Co3287 – CHELSEA ER P23-1(440)

ADDENDUM #2

REVISED: Plan sheets 6, 8, 9, and 37 have been removed and replaced. The Schedule of Items in the Invitation for Bids has been revised to reflect pay item changes.

FILE NAME: s23b796brg	PLOT DATE: 22-SEP-2026
PROJECT LEADER: J. GRIFFIN	DRAWN BY: R. PETZOLDT
DESIGNED BY: A. LEMEIX	CHECKED BY: A. LEMEIX
BEARING DETAILS	SHEET 37 OF 68

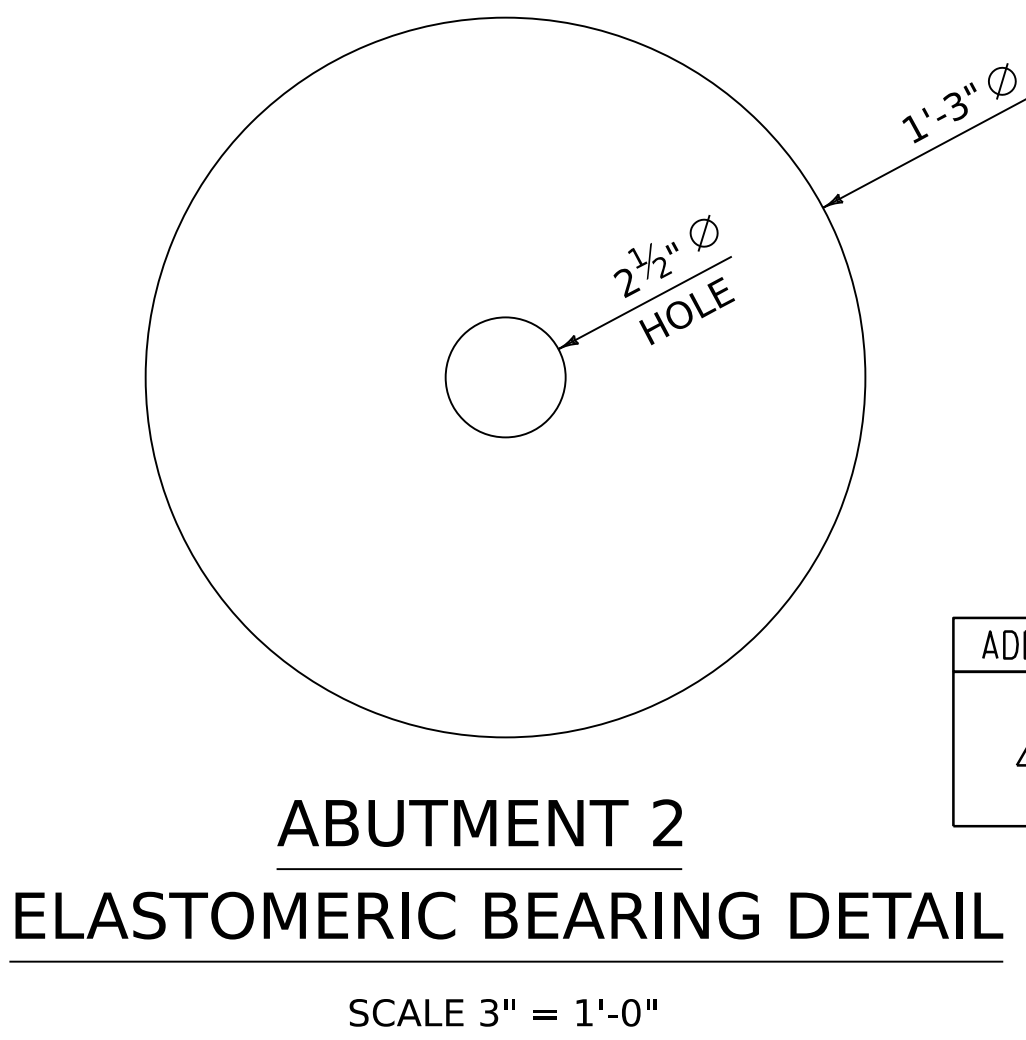
ADDENDUM	REVISION	DATE	DESCRIPTION	BY
2	I	09-22-2026	REQUIRED NUMBER AND THICKNESS OF SHIMS	REP

- SHIMS ARE ANTICIPATED TO BE REQUIRED TO ADJUST FOR FINAL GRADE AND CAMBER TOLERANCES. THE SHIMS SHALL BE 1/2" LARGER DIAMETER THAN THE ELASTOMERIC BEARING AND SHALL NOT BE STACKED. THE CONTRACTOR SHALL BE RESPONSIBLE FOR PROVIDING ADEQUATE SHIMS PROVIDE 14 SHIMS OF EACH THICKNESS FOR THE 1'-0" DIAMETER BEARING. REQUIRED THICKNESSES ARE 1/8", 1/4", 3/8", 1/2", AND 5/8".
